RE: Adequacy Review Response AR-2, M-1986-015

Adequacy Review (10/28/2022) – CWPDA Responses to Comments

Permit #: M-1986-015 Confidential?: N
Class: Revision Type/Seq.: AM-2
From: Continental Materials Corp To: DMG
Doc. Name: EXH C-1 General Site Map
Date: 08/13/2004

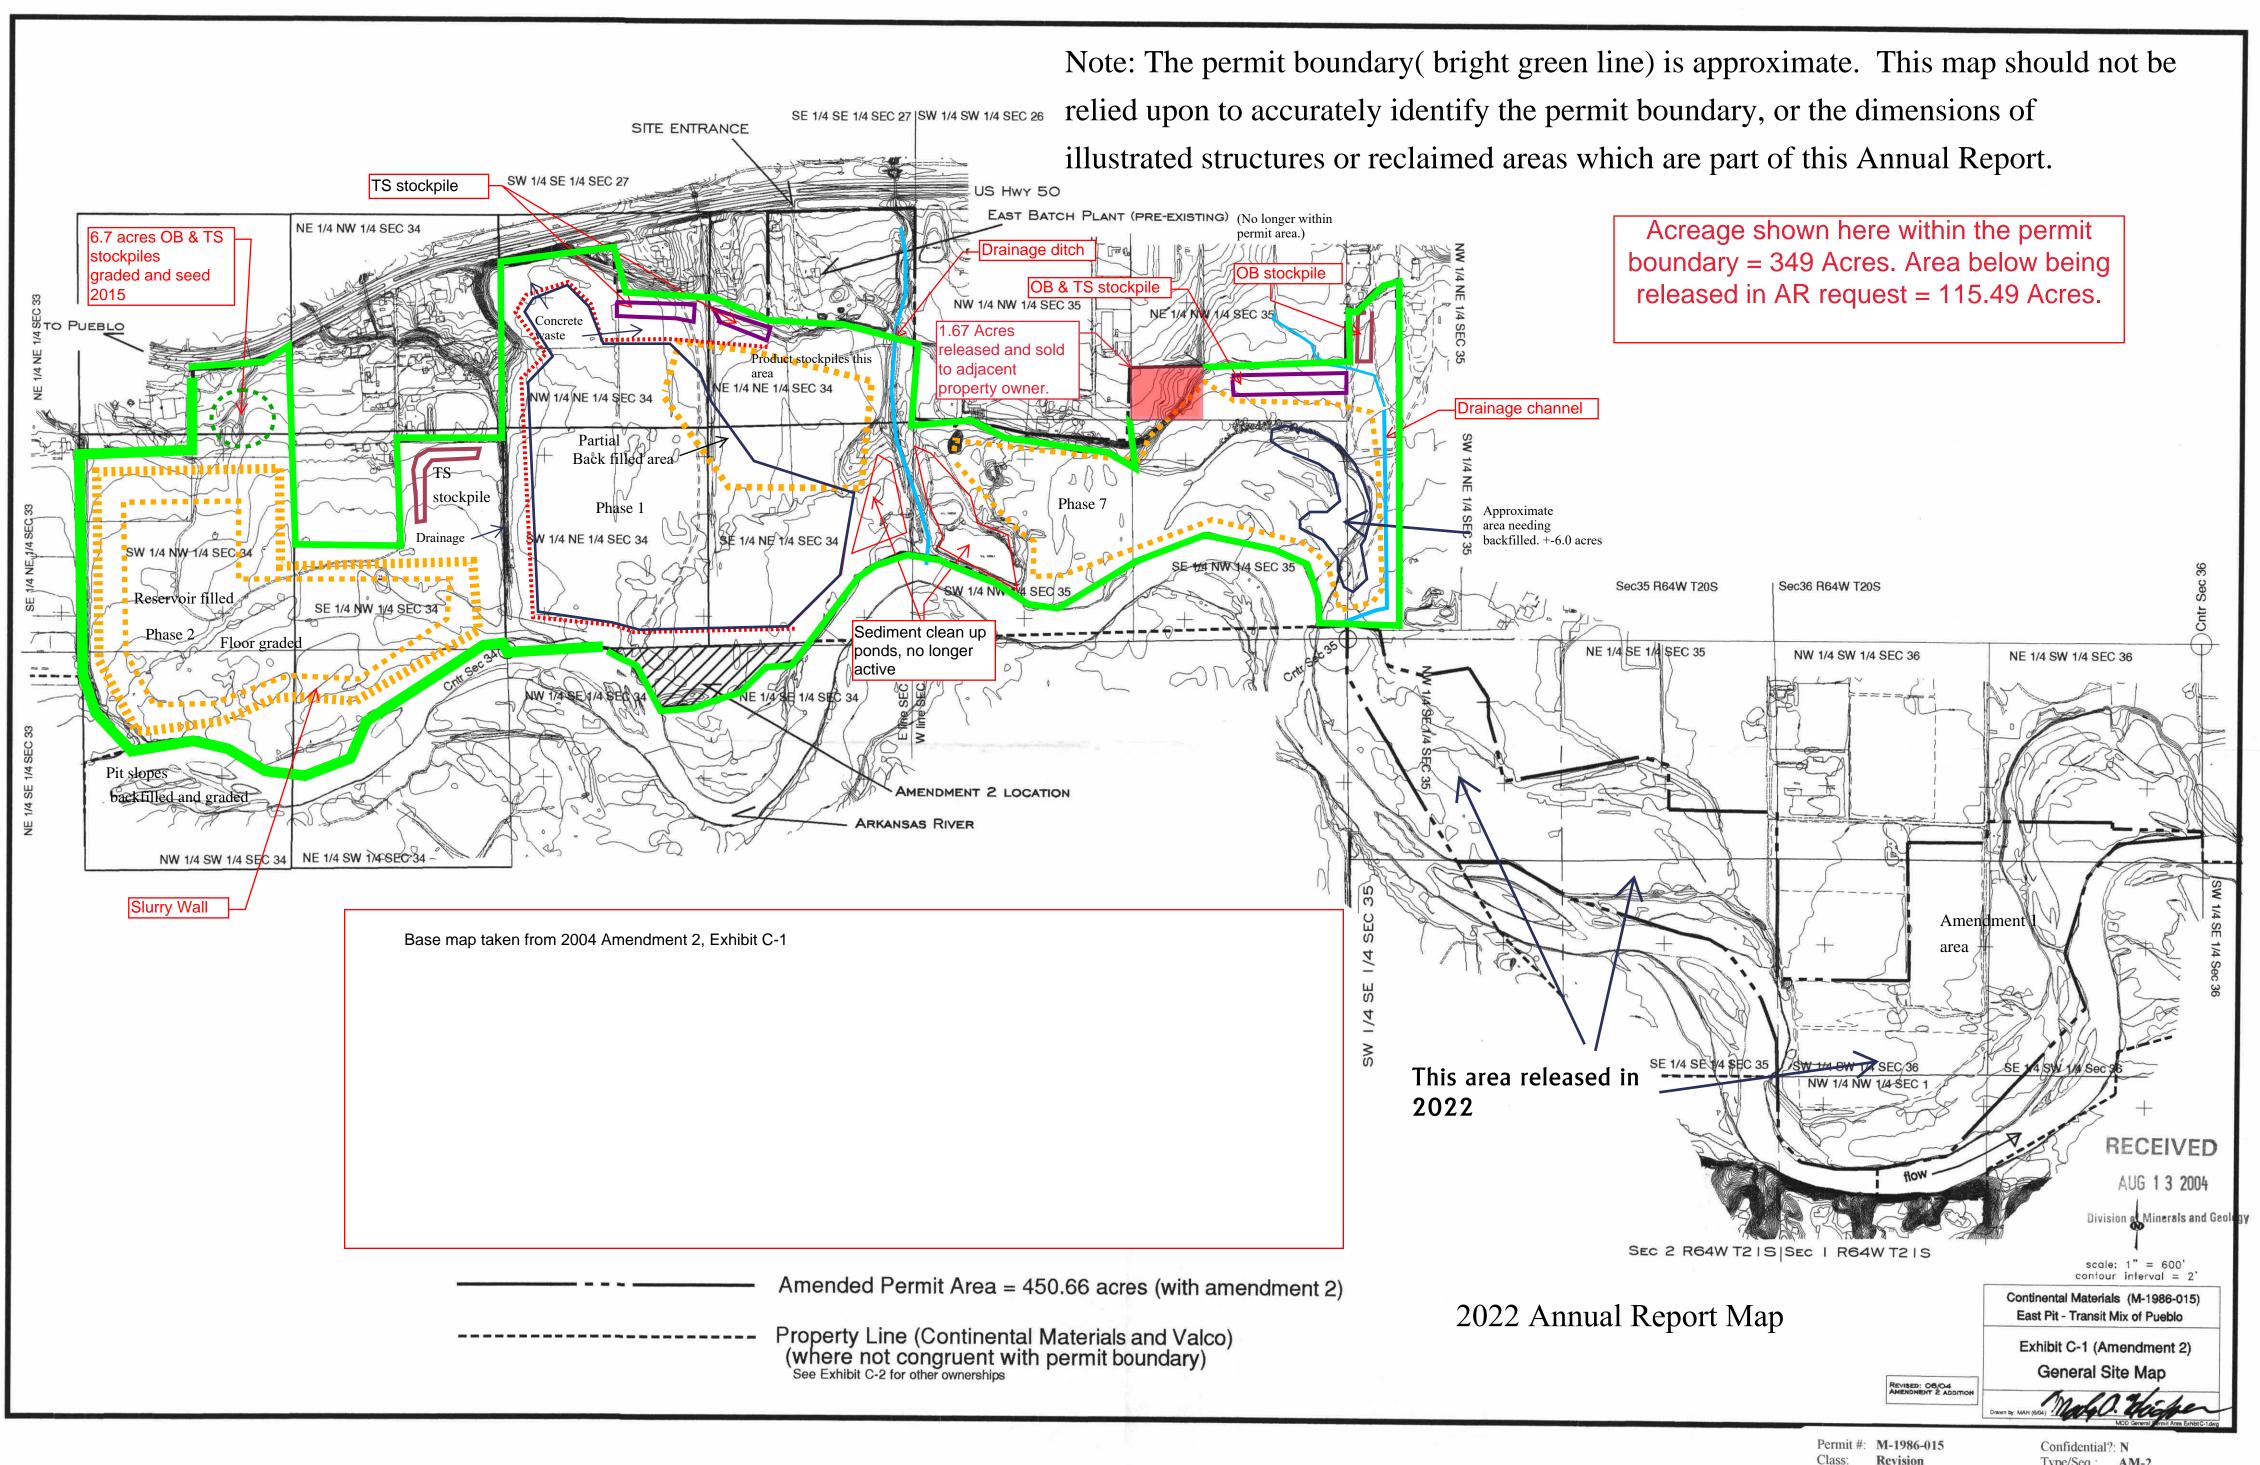
1. The Operator has submitted a request to reduce the current permit area to 349 acres. The currently approved permit acreage is 464.49 acres. In order to get to 349 acres there would need to be a release of 115.49 acres. The request for release is for 123 acres. All release acres are for an area that was added to permit through approval of AM-1 but was never approved to be mined and never was affected by mining. Please provide a detailed acreage accounting of each Phase of the permit area to determine where difference is between the Operator request and the Division's calculated release amounts. The release quest amount can then be refined as needed.

Response: The existing permit boundary encompasses 464.49 Acres. The area which is requested for release is 115.49 Acres. The claimed portion as a remainder under the permit boundary is 349 Acres. These areas can be seen in the two attached maps provided with this adequacy response letter.
